Flintshire County Council

Village Road, Northop Hall

Highways & Transportation Review
06 July 2012

Figure 2.4: Existing Traffic Data

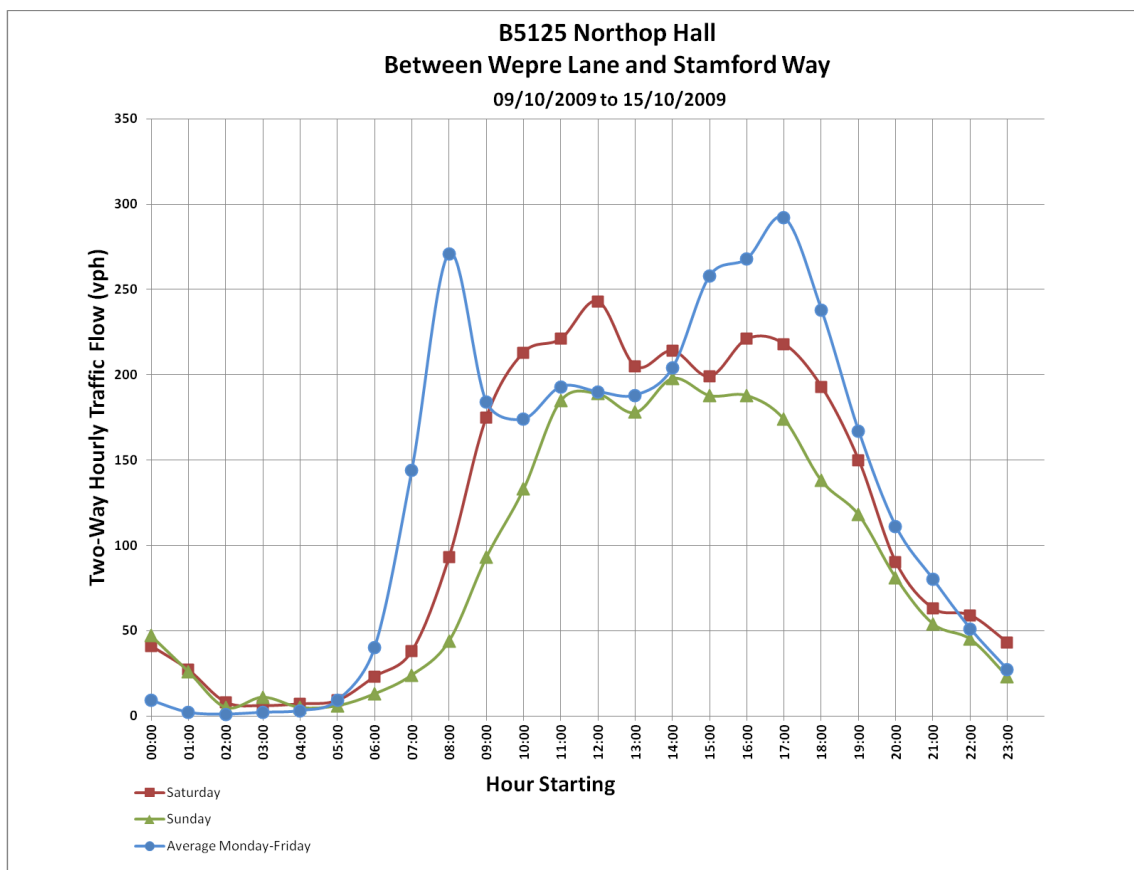
The traffic data shows an evening peak (5pm to 6pm) two-way traffic flow of around 300 vehicles per hour (vph) on B5125, which is equivalent to 5 vehicles a minutes.

The traffic flows recorded on Village Road comparable favourably with those on the B5125 between Wepre Lane and Stamford Way.

There are suggestions from local residents that the B5215 Village Road is used by drivers as a ‘rat run’, including the use of Wepre Lane as an access route through to Connah’s Quay. This would not appear to be borne out by the traffic flow data and I would consider it more likely for traffic to/ from the A55 to use the old the A55 (Chester Road)/ Stamford Way in preference to Brookside/ Village Road, by virtue of the old A55 being derestricted.
